IAE Propulsion System NON-MODIFICATION SERVICE BULLETIN

Subject: Transmittal of Revision 2 to Service Bulletin Number V2500-NAC-78-0167

NACELLE - EXHAUST - LATCH ACCESS DOOR, THRUST REVERSER - SEALING IMPROVEMENT

January 22, 1999 Revision 2 – July 20, 1999 V2500-NAC-78-0167

Latch Access Door Seal Installation ("Skin-and-Stringer")
Figure 1 (sheet 1)

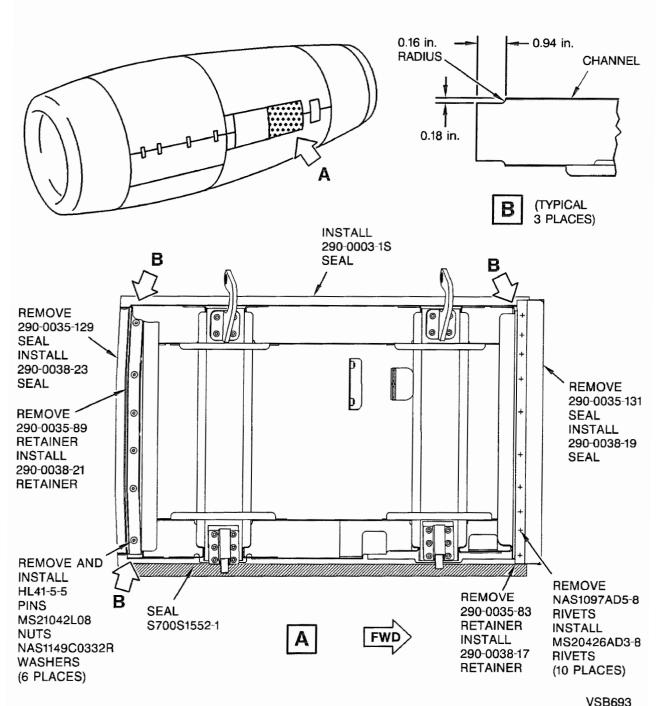
- (1) Remove the pins, collars, washers, 290-0035-89 retainer, and 290-0035-129 seal from the aft edge of the 290-0038-1V (-2V) latch access door. Discard the retainer, seal, and rivets. Refer to Figure 1 (Sheet 1).
- (2) Remove the rivets, 290-0035-83 retainer, and 290-0035-131 seal from the forward edge of the 290-0038-1V (-2V) latch access door. Discard the retainer, seal, and rivets.
- (3) If damaged, or not made of sponge rubber material, remove the seal from the lower edge of the latch access door.

- (d) Apply a thin layer of adhesive (CoMat 08-119) to the seal mating surface of the latch access door. Refer to the manufacturer's instructions.
- (e) Install the 290-0003-1S and S700S1552-1 seals on the "skin-and-stringer" latch access door. Refer to Figure 1 (sheet 1).
- (f) Install the 290-0038-25 and S700S1552-1 seals on the "machined" latch access door. Refer to Figure 1 (sheet 2).
- (g) Cure the adhesive. Refer to the manufacturer's instructions.
- (20) Re-identify the latch access door as follows:

Latch Access Door Seal Installation ("Machined")
Figure 1(sheet 2)

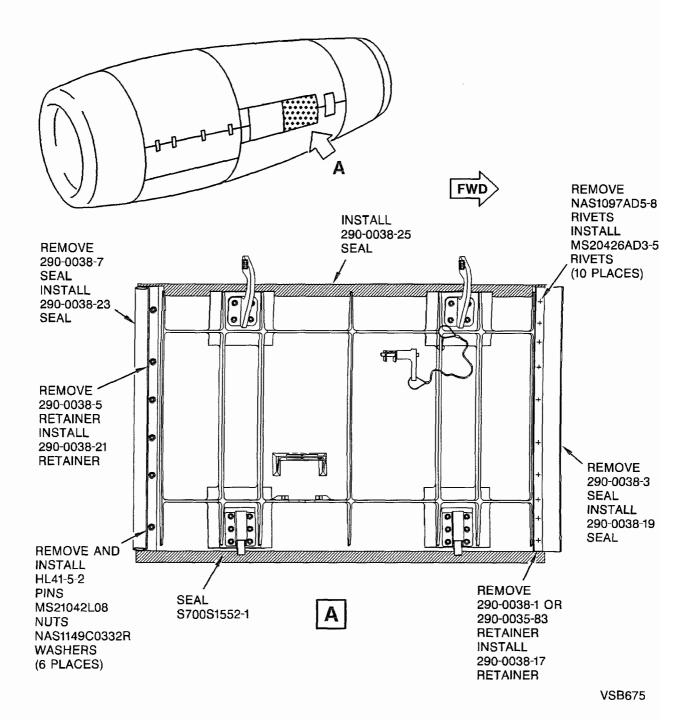
- (12) Remove the pins, collars, washers, 290-0038-5 or 290-0035-83 retainer, and 290-0038-7 seal from the aft edge of the 290-0038-514 (-515) latch access door. Discard the retainer, seal, and rivets. Refer to Figure 1 (sheet 2).
- (13) Remove the rivets, 290-0038-1 or 290-0035-83 retainer, and 290-0038-3 seal from the forward edge of the 290-0038-514 (-515) latch access door. Discard the retainer, seal, and rivets.
- (14) If damaged, or not made of sponge rubber material, remove the seal from the lower edge of the latch access door.

- (a) If there is excessive looseness or "free-play", check for proper installation of the attach hardware and replace any worn, damaged, or missing bushings. Refer to Figure 2.
- (3) Adjust the latch access door aft seal. Refer to Figure 1 (sheets 1 and 2).
 - (a) Move the 290-0038-23 aft seal until it is compressed 10% to 30% against the translating sleeve when the latch access door is closed.
 - (b) Torque the MS21042L08 nuts to 12 to 16 inlbs.

Latch Access Door Hinge Point Attach Hardware Figure 2 (sheet 1)

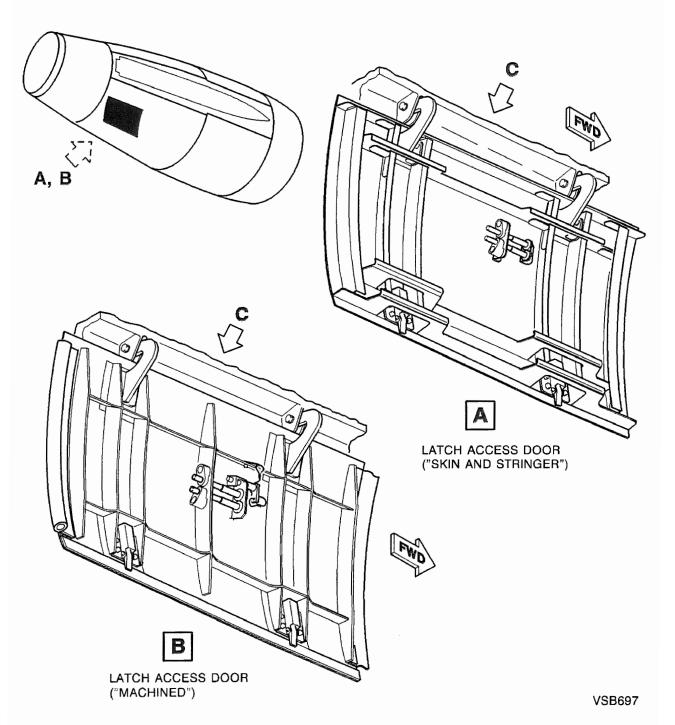
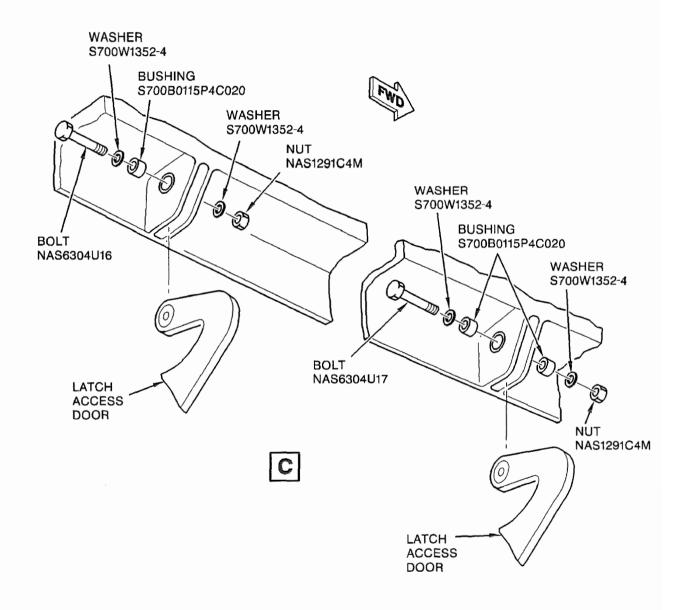
- (21) Repair the external paint on the latch access door. Refer to the MD-90 Structural Repair Manual, Chapter 54-30-03, External Paint repair VRS2404.
- (22) Examine the upper outboard track beam latch access door hinge point bushings. Replace any damaged or missing bushings. Refer to Figure 2.

Upper Outboard Track Beam Latch Access Door Hinge Point Bushings Figure 3

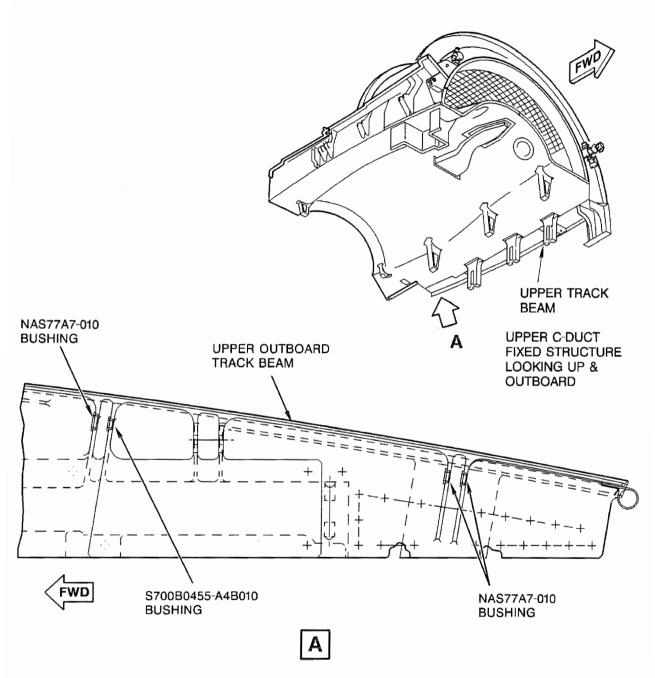
- (16) Torque the MS21042L04 nuts to 12 to 16 inlbs.
- D. Post-requisite instructions
 - Install the latch access door. Refer to the MD90 Aircraft Maintenance Manual, Chapter 78-32-(1)09, Page Block 401. Make sure all the track beam bushings and door installation bushings are present and installed correctly. Refer to Figures 2 and 3.

Track Beam Seal Installation Figure 4 (sheet 1)

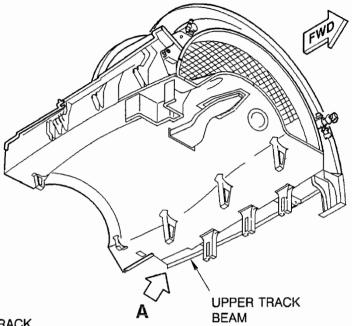
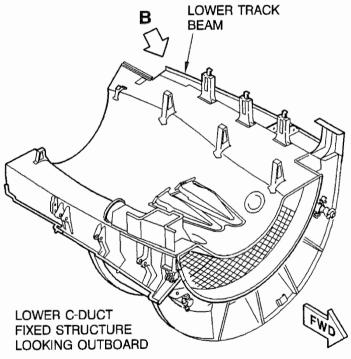
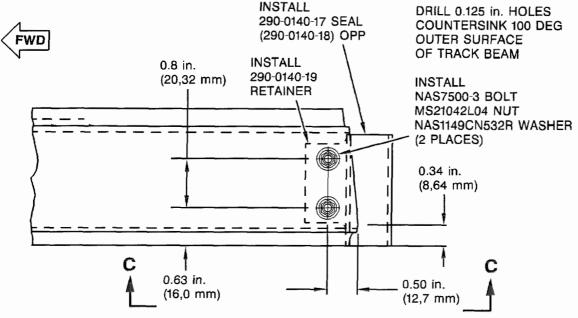
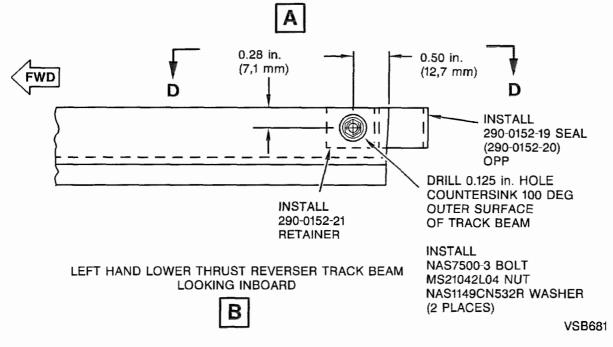
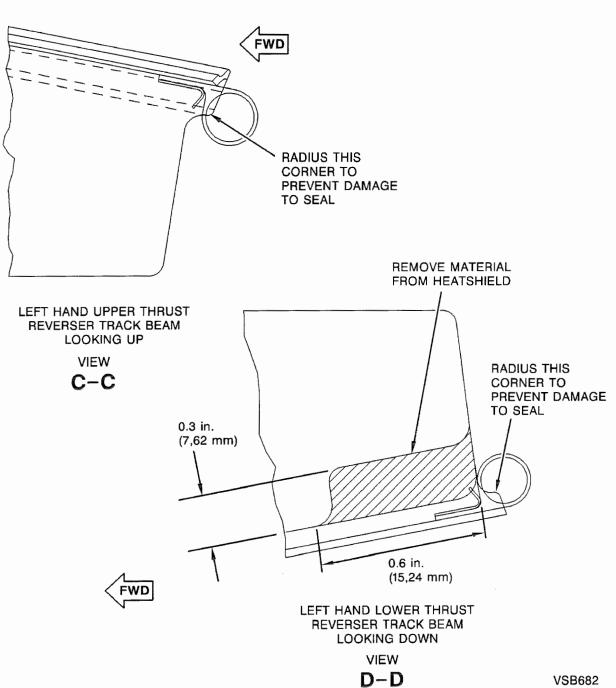
- (23) Examine the translating sleeves for heat damage around the latch access door and the double latch and repair as necessary. Refer to Chapter 78-32-16 of the MD90 Thrust Reverser Component Maintenance Manual (CMM-TR-V2500-3IA) for inspection and repair instructions.
- C. Install the 290-0140-17 (-18) and 290-0152-19 (-20) seals on the track beams. Refer to Figure 3.

- (4) Apply sealant (CoMat 08-030) to the cut edges of the track beam heatshield.
- (5) Cure the sealant. Refer to the manufacturer's instructions.
- (6) Put the 290-0140-17 (-18) seal and 290-0140-19 retainer into position on the upper track beam.
- (7) Put the 290-0152-19 (-20) seal and 290-0152-21 retainer into position on the lower track beam.
- (8) Drill the holes for the attaching parts.

- (14) Retract the translating sleeves to the stowed position. Refer to the MD-90 Aircraft Maintenance Manual, Chapter 78-32-00, Page Block 201.
- (15) Move the 290-0140-17 (-18) and 290-0152-19 (-20) seals until they are 10% to 30% compressed against the translating sleeve.
